LATEST REVISION DATE 09-14 APPROVED BY BRIDGE ENGINEER 	 Iowa Department of Transportation Highway Division
	STANDARD DESIGN - 24' ROADWAY, 3 SPAN BRIDGES CONTINUOUS CONCRETE SLAB BRIDGES NOVEMBER, 2006
	WING ARMORING DETAILS
J24-43-06

TOP VIEW OF WING ARMORING

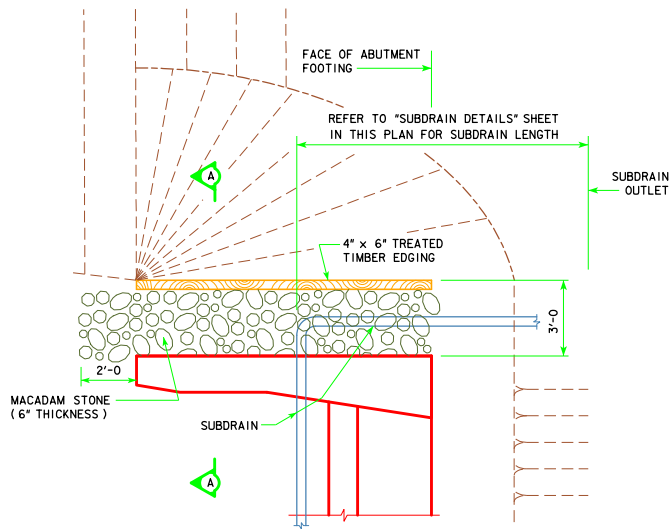
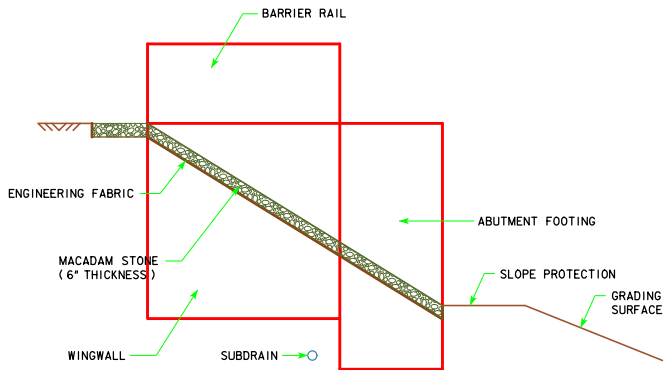
REVISED 09-14 - THE AREA OF MACADAM STONE WAS EXTENDED 2'-0" IN FRONT OF THE BRIDGE WING.
